Appl. No. 10/065,482
Amdt. dated January 09, 2006
Reply to Office action of October 20, 2005

Amendments to the Drawings:

REMARKS/ARGUMENTS

Fig. 1 Prior art

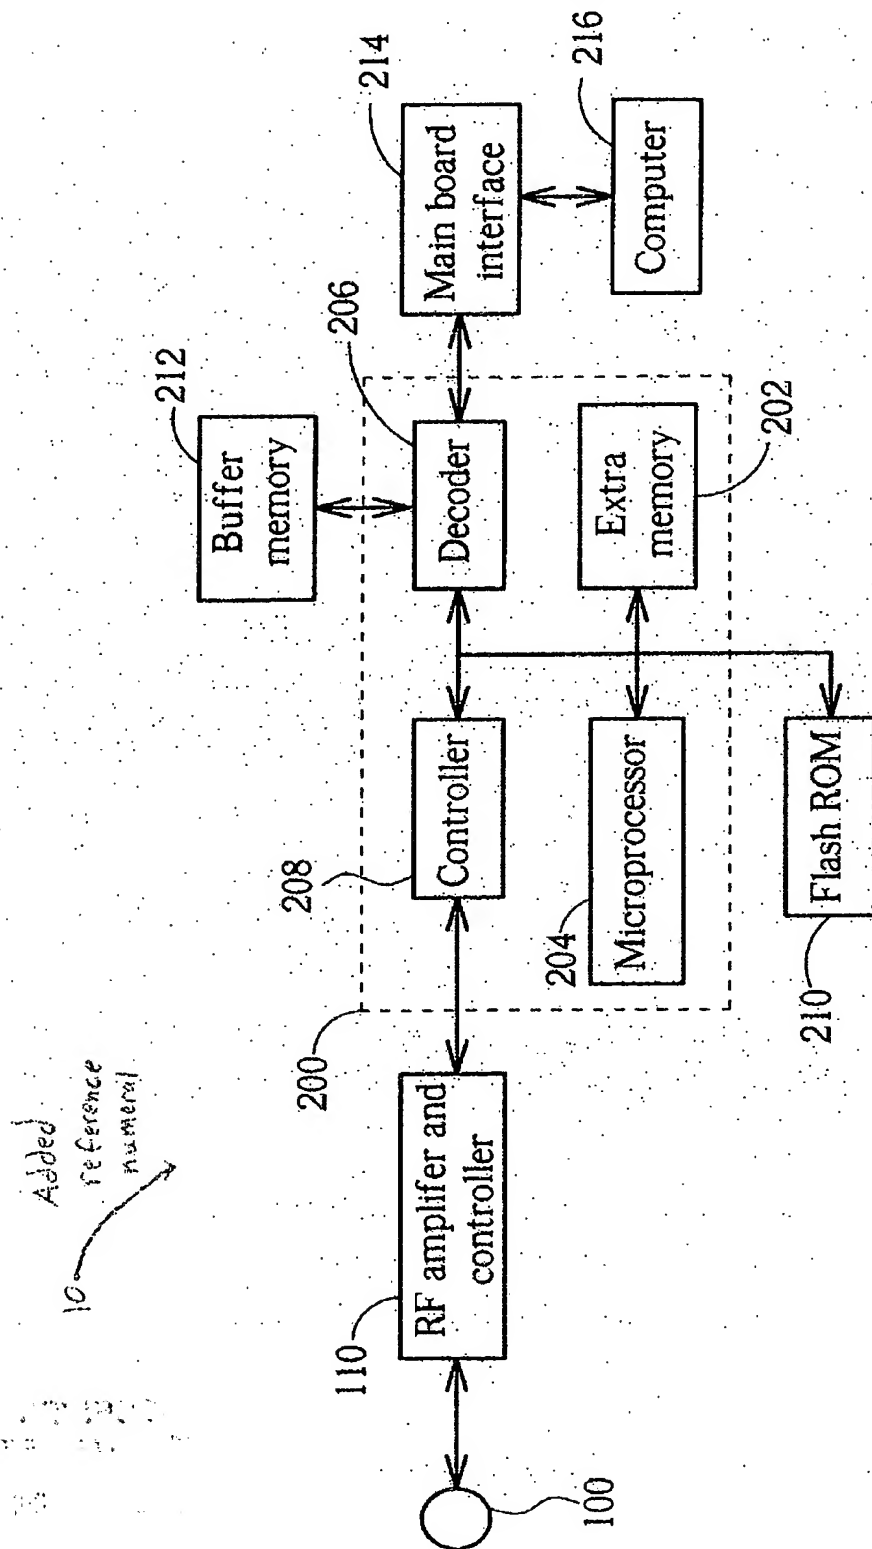
- 5 Figure 1 now contains reference numeral 10 to identify the optical disk system 10. Figure
4 contains reference numeral 20 to identify the optical disk system 20. In addition, the
reference numeral 200 has been replaced with 201 to distinguish the present invention
optical disk system control chip 201 having the control circuitry 500 from the prior art
optical disk system control chip 200. No new matter is added through these amendments
10 to the drawings or the specification.

Figures 1 and 4 have been amended, and paragraphs [0005] and [0032] of the specification have been amended to match the amendments to the figures.
